Subject: FW: Email - Request to Speak - Meghan Mickelson - Northeast Swale and Small Swale Boundary

Swale Watchers' Vision for the Swales: Problems and Solutions

February 17, 2023

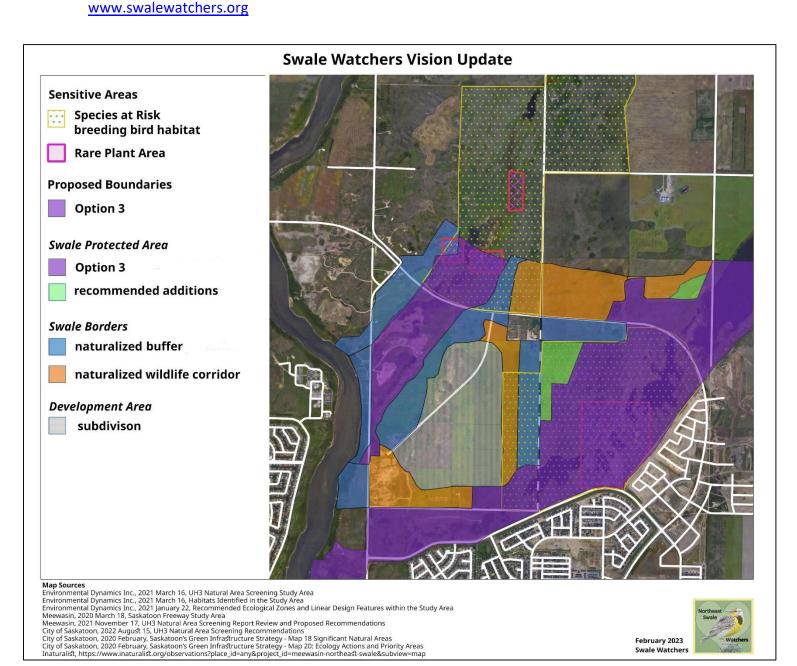
1. Protect the 40-acre triangle of habitat in the northwest corner of the Northeast Swale to secure the future of the sharp-tailed grouse. See map at the end of this document.

2. Provide a protective buffer around the northwest corner of the Northeast Swale, further safeguarding the lek. See map.

A potentially disastrous feature of all three options presented by city administration is the lack of connectivity between the two Swales and between the Northeast Swale and the river. On these maps, the only provision for animal movement is indicated by two dotted lines crossing the subdivision. When wildlife biologist Dr. Ryan Brook of the University of Saskatchewan reviewed this feature, he identified these linear passageways as "pinch points." In other words, rather than serving as corridors, these narrow passageways would function as barriers to animal movement.
